December 18, 2002

SUBJECT: Revised Submittal of Quality Assurance Program for
Station Operation
R. E. Ginna Nuclear Power Plant
Docket Number 50-244

In accordance with 10 CFR 50.54(a)(3), enclosed is Revision 30 to the Quality Assurance Program for Station Operation (QAPSO) for the R.E. Ginna Nuclear Power Plant. Revision 30 incorporates the following changes:

FIGURE 17.1.2-1

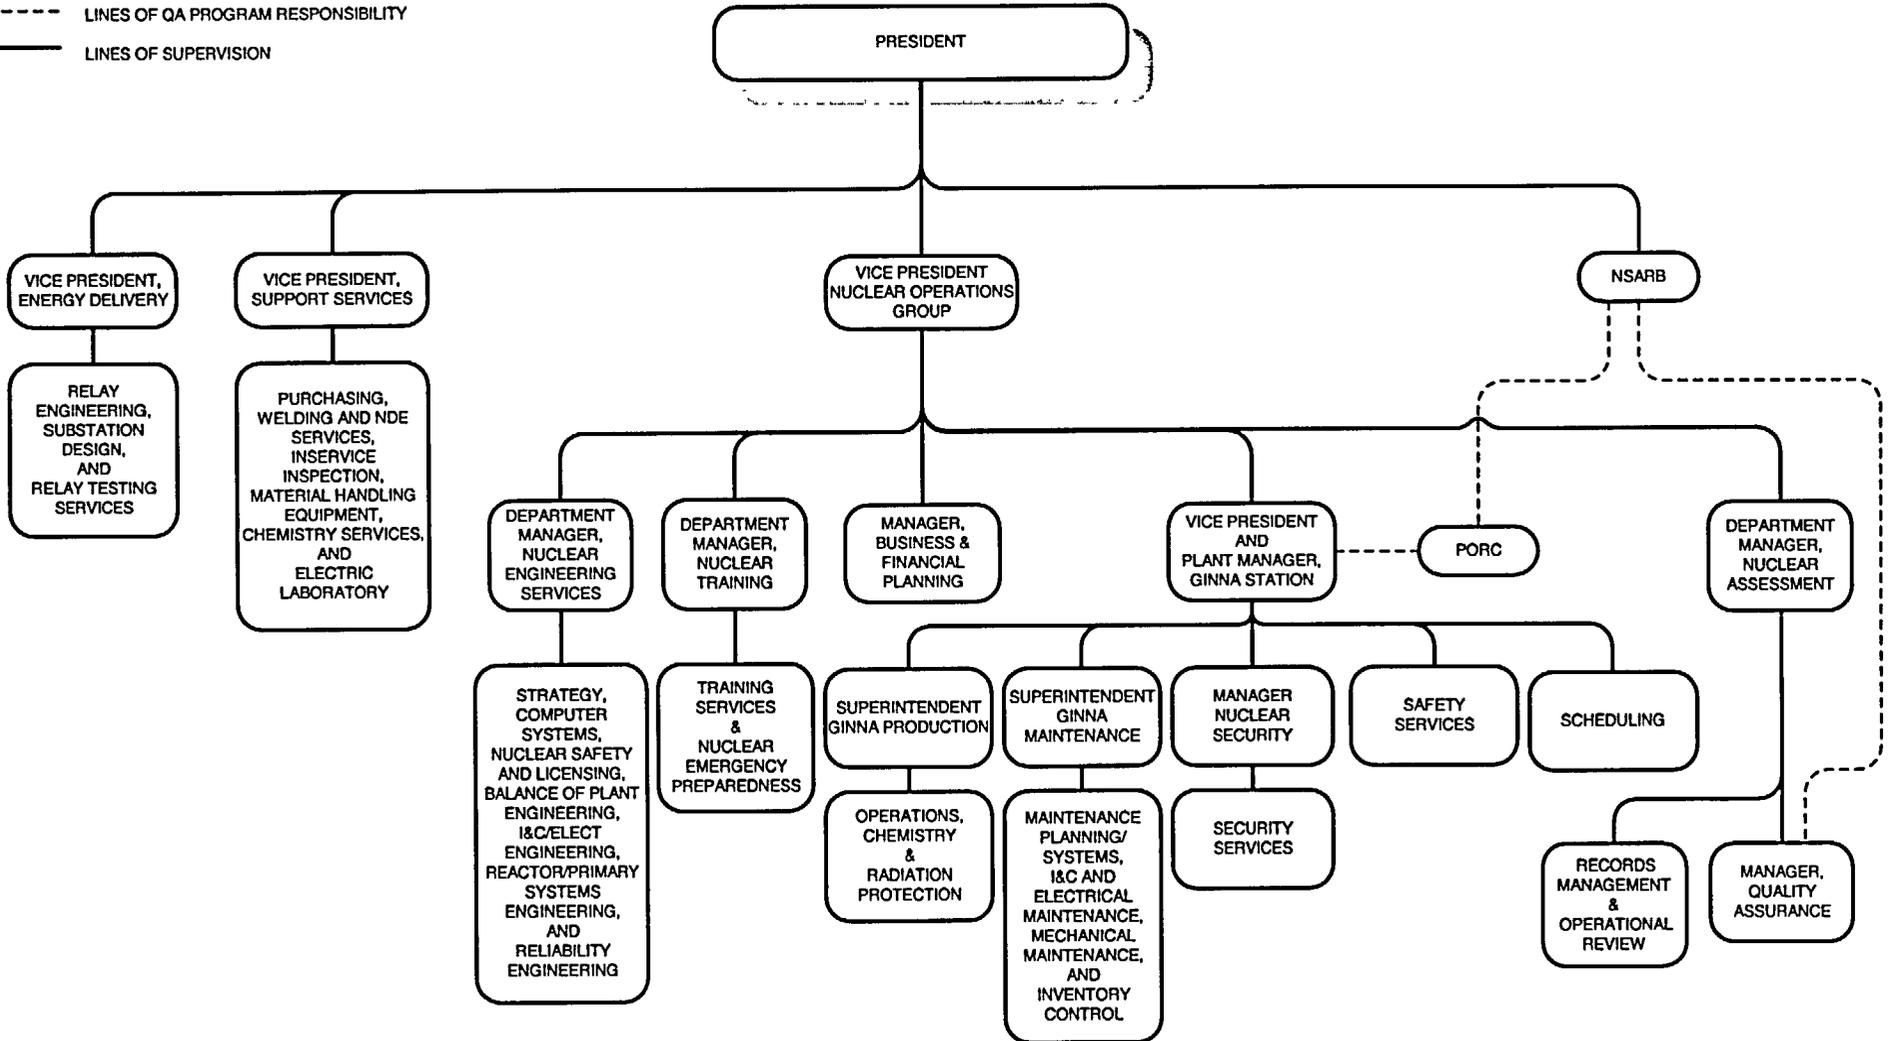
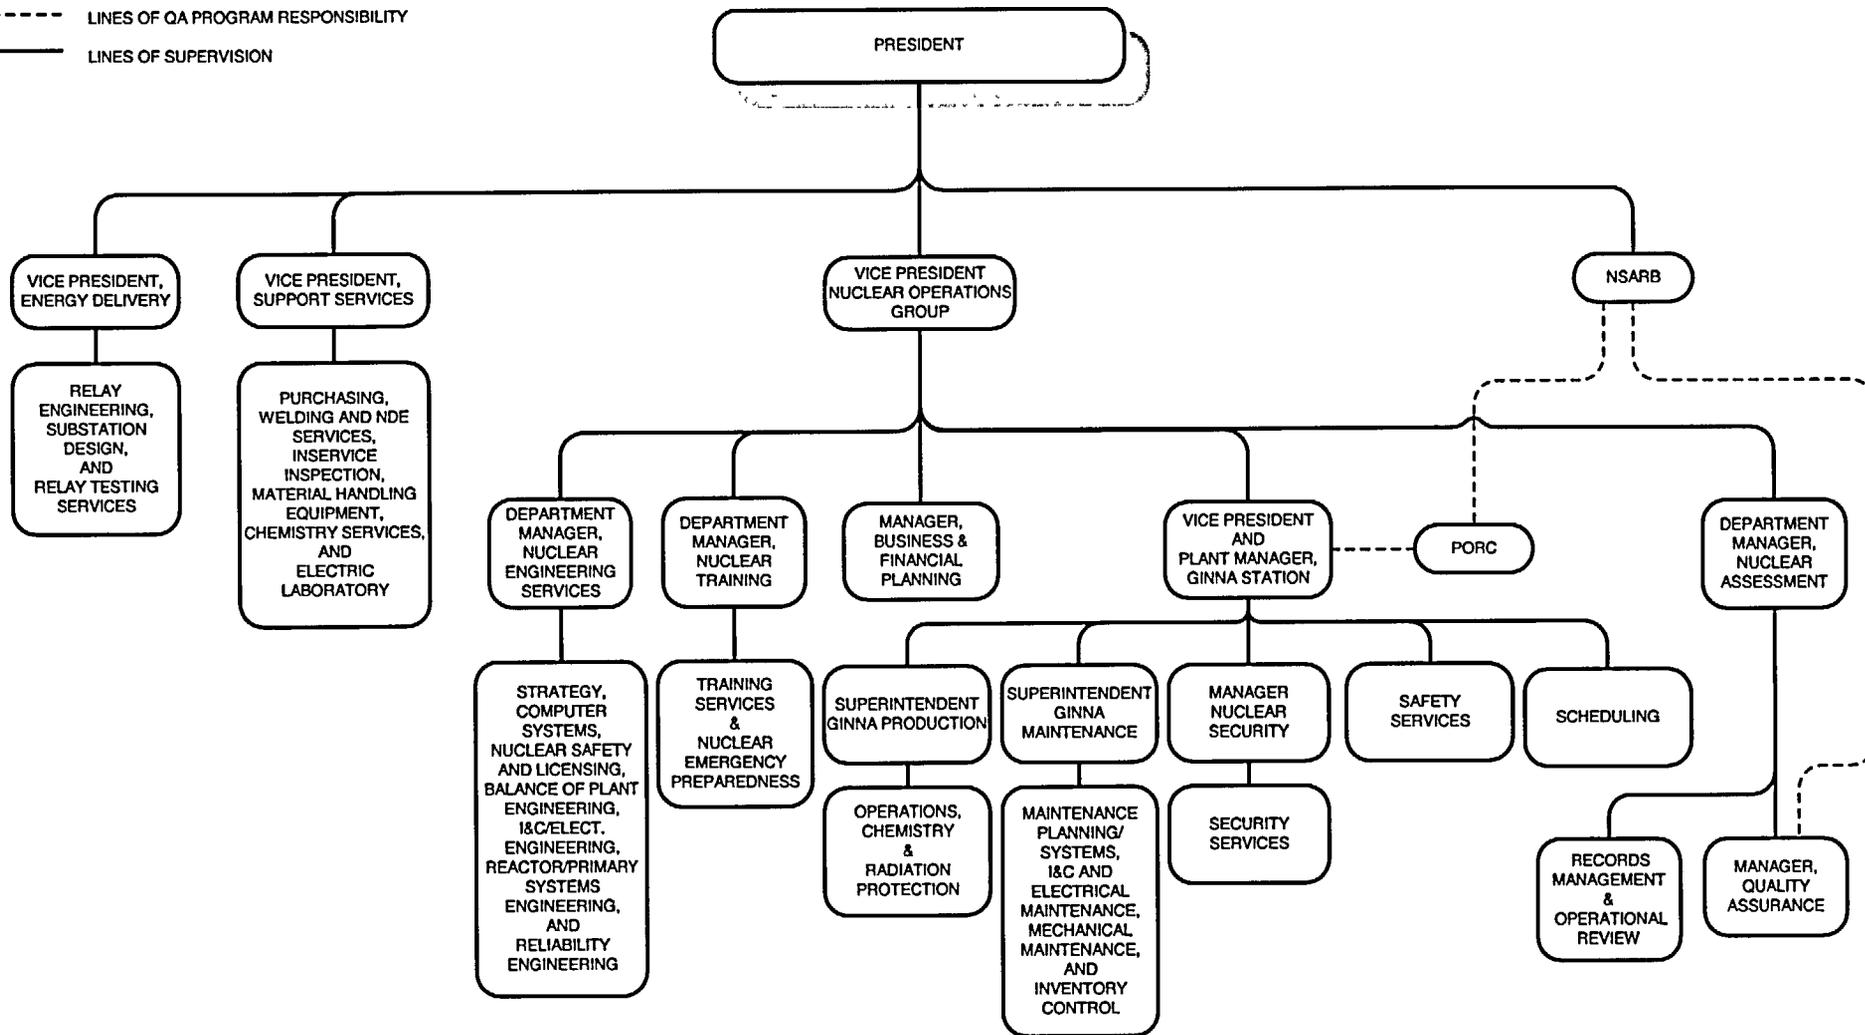
The following organization changes are reflected throughout the text of the document and on the Figure 17.1.2-1 Organization Chart:

Eliminated position.

A corporate merger eliminated the Senior Vice President's position.

Clarify reporting relationship of the QA organization to the NSARB. Quality Assurance Program and assessment responsibilities of the Department Manager, Nuclear Assessment have been transferred to the Manager, Quality Assurance.

Changed title to "Chemistry & Radiation Protection" on the Figure 17.1.2-1 Organization Chart.

The responsibilities of the Senior Vice President have been reassigned to the President and the Vice President, Nuclear Operations Group. Since no responsibilities have been eliminated and no QA/QC functions have been transferred to the line organization, the above change is not considered to be a reduction in commitment.

Since no responsibilities have been eliminated and no QA/QC functions have been transferred to the line organization, the above change is not considered to be a reduction in commitment.

Since no responsibilities have been eliminated and no QA/QC functions have been transferred to the line organization, the above change is not considered to be a reduction in commitment.

Since no responsibilities have been eliminated and no QA/QC functions have been transferred to the line organization, the above change is not considered to be a reduction in commitment.
